Ad Hoc Committee Agenda Item #:	II A – Action Item
Date:	December 4, 2019
To:	Magnolia Educational & Research Foundation dba Magnolia Public Schools (“ MPS ”) Ad Hoc Committee (the “ Committee ”)
From:	Alfredo Rubalcava, CEO & Superintendent
Staff Lead:	Patrick Ontiveros, General Counsel & Director of Facilities
RE:	MSA-1 Change Order Requests

COR/PCI	DESCRIPTION	COMMENTS / EXPLANATION	COST
42	Extended General Conditions Reconciliation	<p>Change order request includes costs associated with the extension of general conditions from the previously reconciled substantial completion date of July 2, 2019 to the actual substantial completion date of September 18, 2019. The project dates were impacted due to the delay in the release of power by DWP--the meter was energized on August 26, 2019--and the release of LADBS sign offs allowing for occupancy.</p> <p>Includes a credit for the non-installation of the Proto II wall. The City of LA would not issue a permit for its construction without a lot tie. A lot tie was only feasible following approval of the zone change.</p> <p>General conditions are the contractor's direct costs and overhead.</p>	\$60,364.82
43	Electrical Added Scope to existi

NOT APPROVED - CORRECTION NOTICE

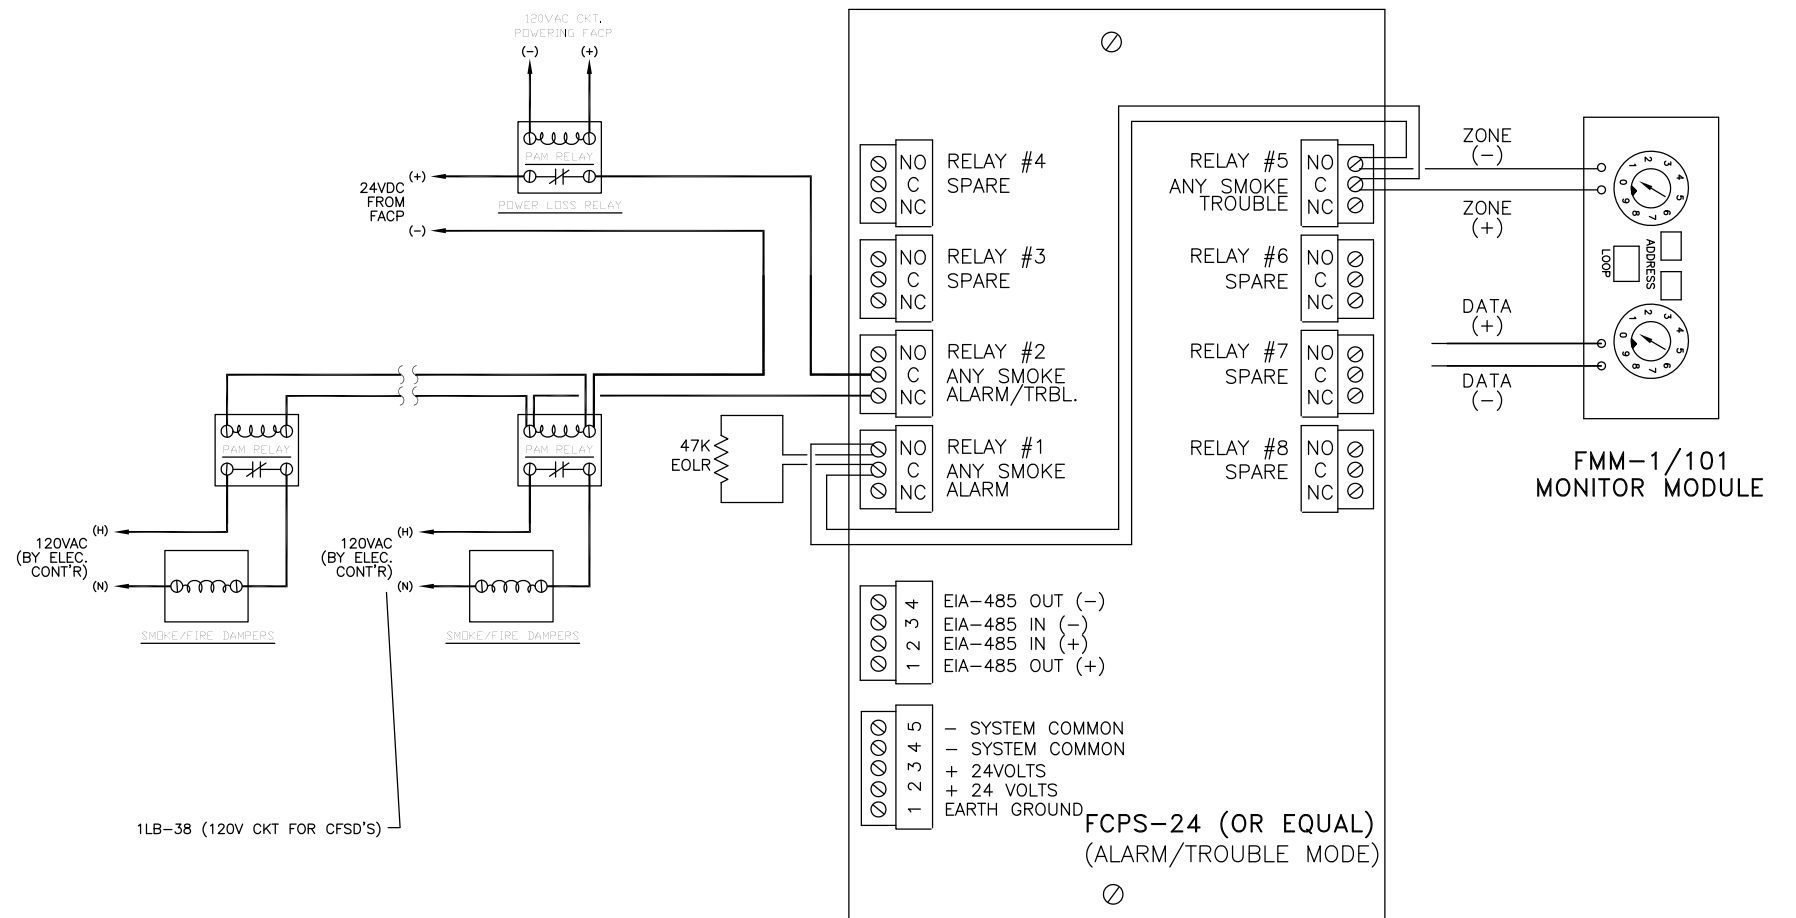
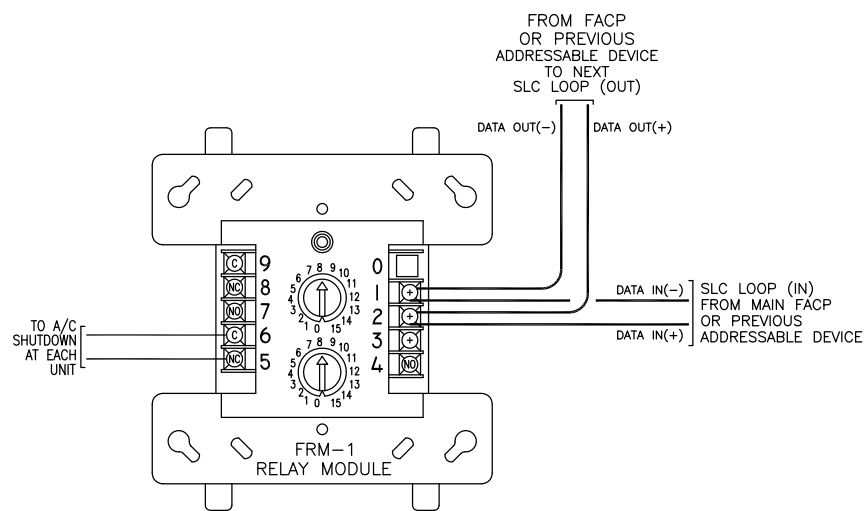
JOB ADDRESS: 18220 W SHERMAN WAY			PERMIT #: 17044-20000-07122	CONFIRM #: 25305989
JOB DESCRIPTION: HVAC			FOR REINSPECTION CALL: (888)LA4-BUILD or 311 INSPECTOR: KEVIN BROWN DISTRICT: HVACVN1 PHONE: (818) 374-1153 BUREAU: Inspection Bureau DATE: 8/13/2019	
APPLICANT/AGENT: CHRISTIAN BROTHERS MECHANICAL SERVICES INC				
ADDRESS: 11140 THURSTON LANE				
CITY: MIRA LOMA	STATE: CA	ZIPCODE: 91752		
<p>Before the work or installation authorized by this permit can be approved, concealed, energized, or used, the following deficiencies shall be corrected. Call for reinspection when all corrections have been made.</p>				
<p>PERMIT GROUP/TYPE/SUBTYPE: Mechanical/HVAC/Commercial INSPECTION TYPE: VENTILATION-Final</p>				
<p>VIOLATION NUMBER: 19-DMN-141-G-3346 Date Issued: 8/14/2019 Issued by VIOLATION TYPE: LAMS Smoke/Fire Damper Smoke Detection VIOLATION CODE SECTION: 95.606.1 LAMC CODE LANGUAGE: Provide duct detector within 5 feet of each smoke/fire damper in the airstream or provide full area coverage (716.3.2.1 CBC). VIOLATION NOTES: Second</p>

<p>VIOLATION NUMBER: 19-DMN-141-G-3410 Date Issued: 8/14/2019 Issued by VIOLATION TYPE: Fan Shutdown VIOLATION CODE SECTION: 95.609.0 LAMC CODE LANGUAGE: Provide duct detector in the main supply air plenum of all air moving systems in excess of 2000 CFM combined, such systems shall shutdown simultaneously without delay. VIOLATION NOTES: Second</p>

1 WEST WALL

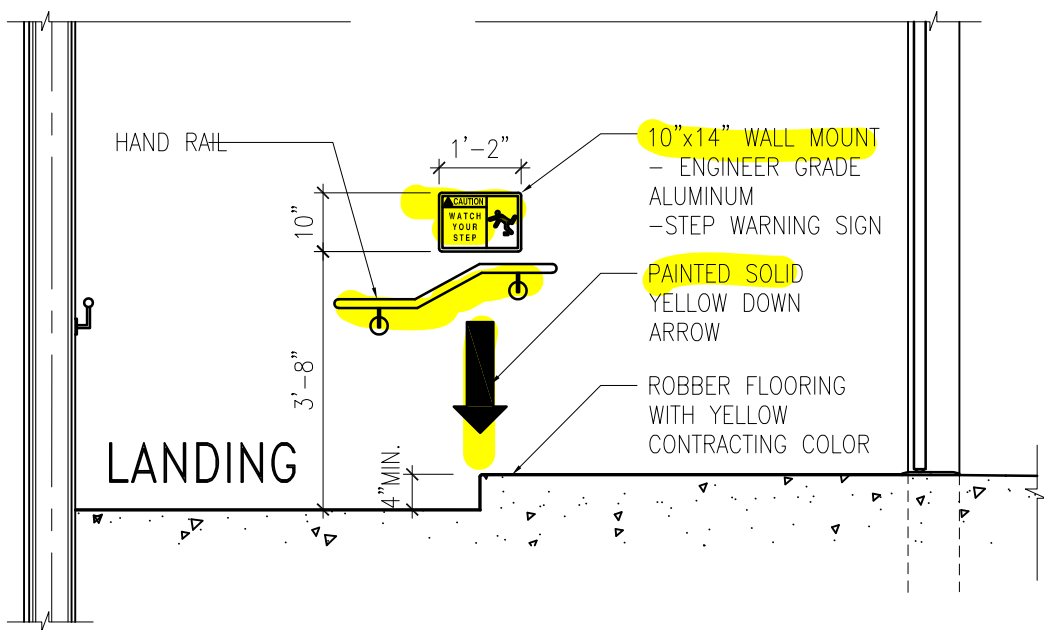
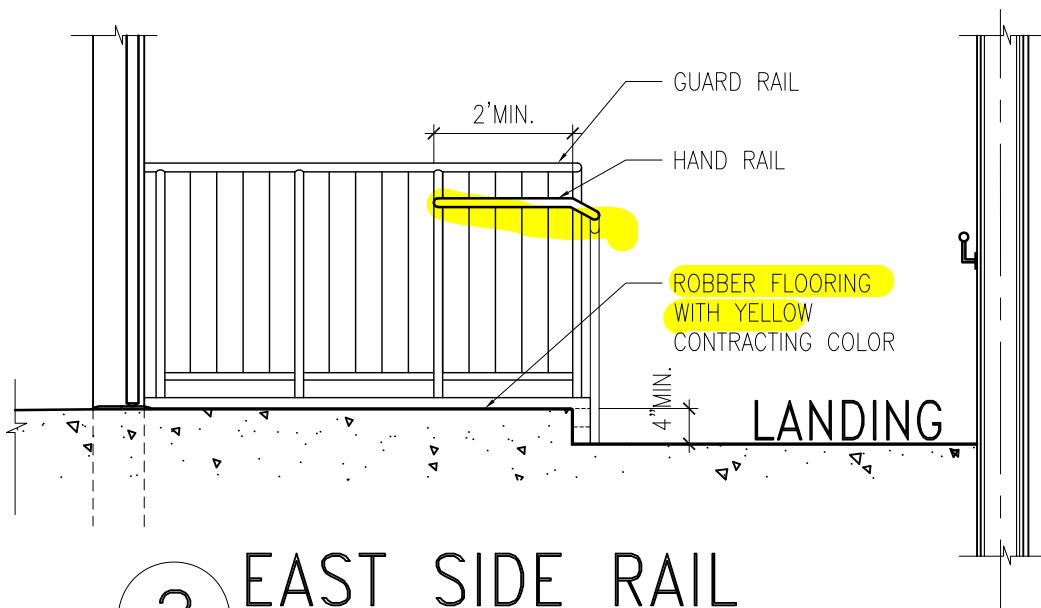
3. Adjust hand railing at the landing due to added step (stair #2, roof top only) on the previously approved shop drawing 051200-03 Stairs Shop Drawings FAC 071018.

Add hand rail & backing per jobsite walk after OAC 5/8/19.

Change hand rail & backing per jobsite walk after OAC 5/8/19.

8/A9.3 - RFI 173 Chem Lab #201

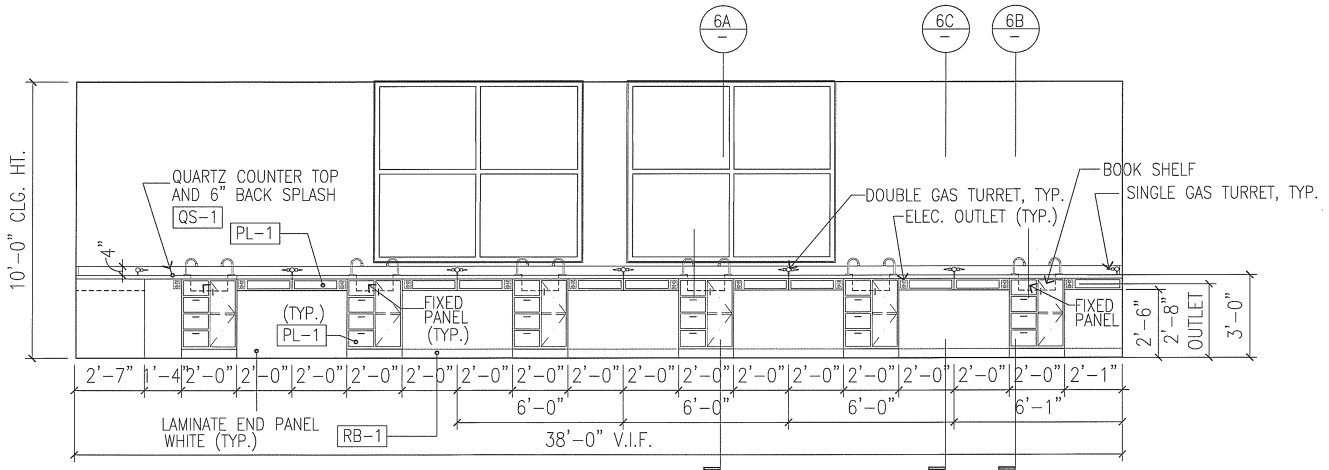
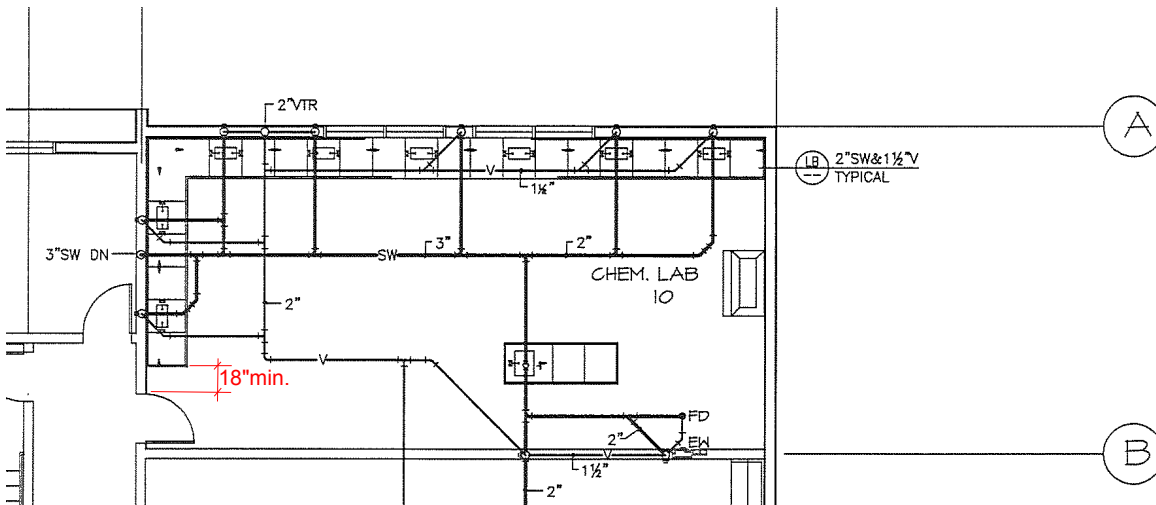
The Chemistry Lab room #201 has full height windows facing North above the lower cabinets. See A9.3 detail 8. The windows are type "A" found on A10.1. The plumbers have no way to run their waste and vents. We have large structural beams above and below. The 18" cavity between the windows are full of structural posts etc. There is no room to run a vent or waste up or down this 18" cavity.

Provide about 4" full-height furring on north wall to accommodate the plumbing work.

Adjust the cabinet work at the north-west corner.

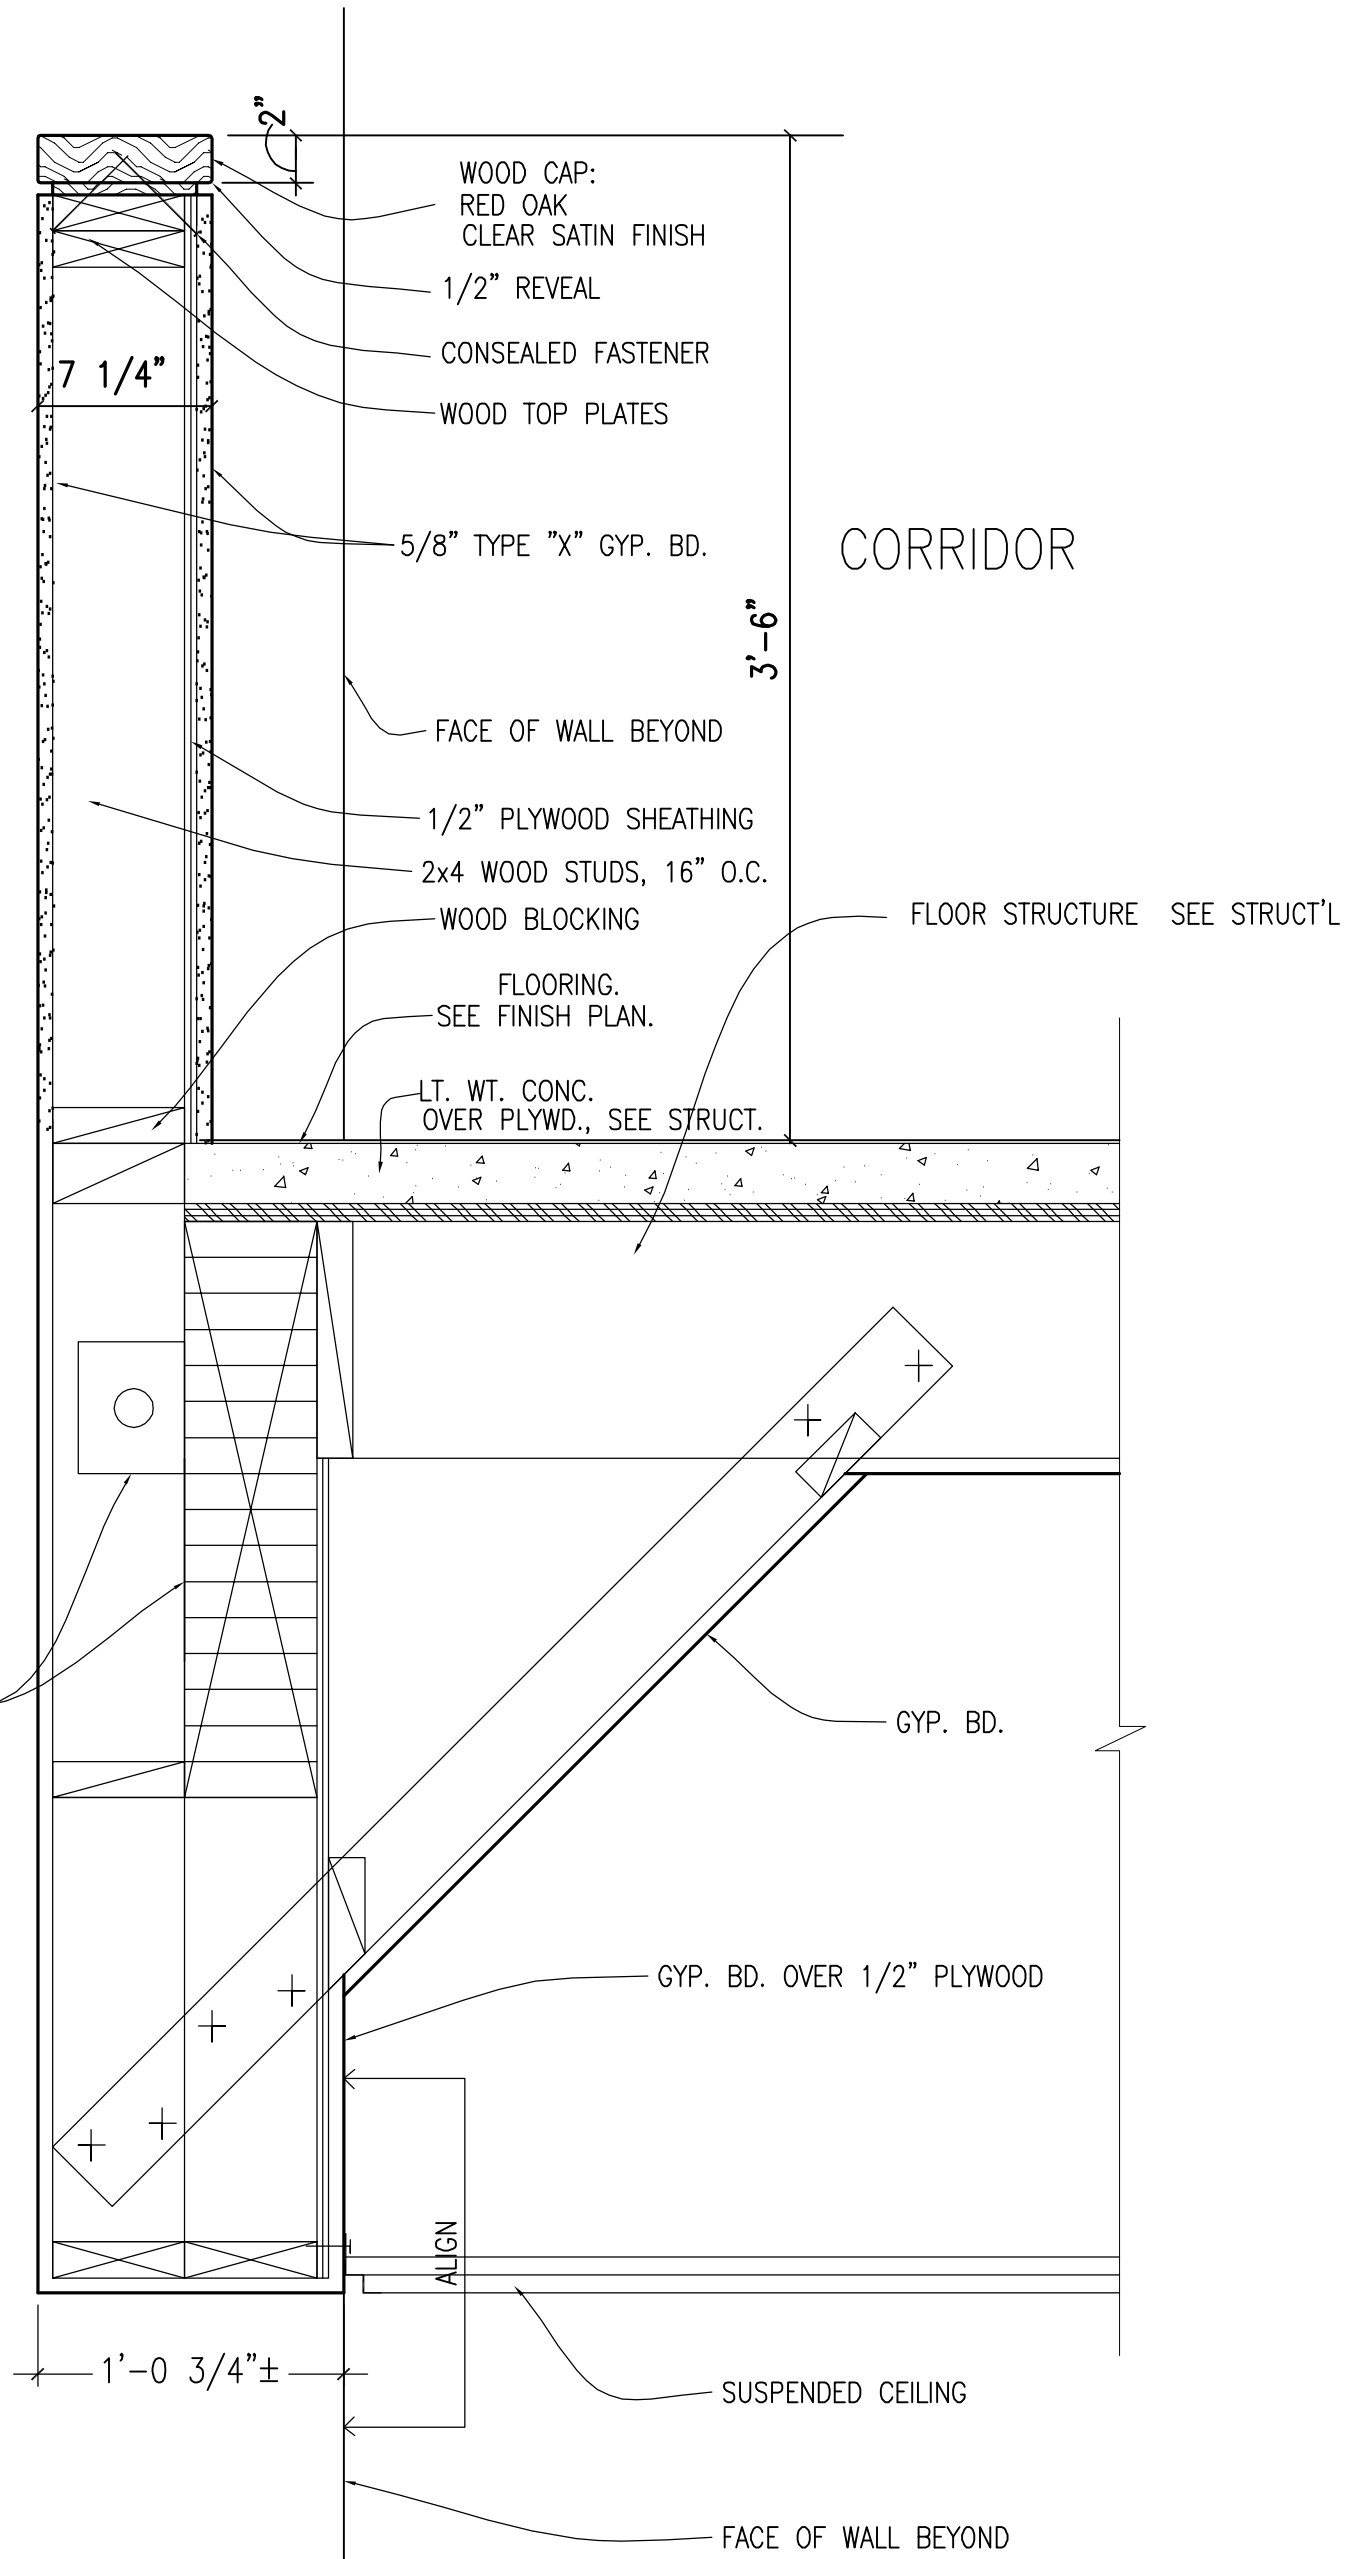
As discussed with Johann at job walk 3/20/19: At 2nd floor 2/ A6.2 shows the low wall on top of the beam; this is the incorrect detail. Sheet S6.3 detail 11 shows the low wall / curtain wall bolting to the beam; this is the correct detail we followed. The bottom of the curtain wall needs to be widened by 6". Please confirm.

Follow SK-034 which was submitted with RFI #129. This is confirmed.

2NDFLOOR ATRIUM

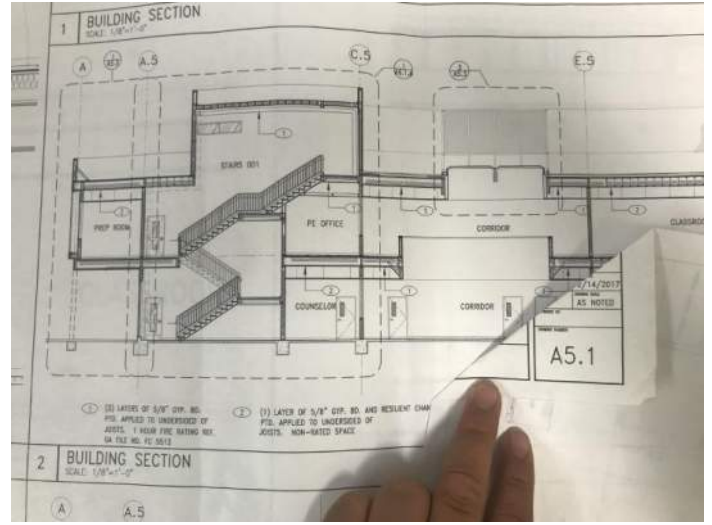
JEFF(SUPERINTENDENT) DIRECTED US TO BUILD A SOFFIT AT THE ROOF LEVEL JOIST INLINE WITH THE WALL.by Johann on our job walk Wednesday to provide a change at the ceiling line on the 2nd floor. The atrium area has a 'hard lid". The 2nd floor corridor is t-bar. This is shown on A 2.2 RCP. The hanging curtain wall which divides the t-bar from the hard lid is in question. Sheet A 2.2 clearly shows the curtain wall dividing the t-bar from the hard lid area. However, A5.1 shows the hanging curtain walls located around the skylights. There is a discrepancy on where the curtain walls are to be located. I was told by Johann to follow the A2.2 RCP plan.

We then have a dropped hard lid area under the skylights. This is shown on A2.2 RCP. Johann has directed Oltmans to hang the drywall directly to the bottom of the TJI's, beams etc as shown on A5.1 detail 2. The dropped hard lid in this area will no longer be installed. While the hanging hard lid will be omitted, the wood framers will need to do some furring to hide some bolts etc, and drywall will need to finished taped.
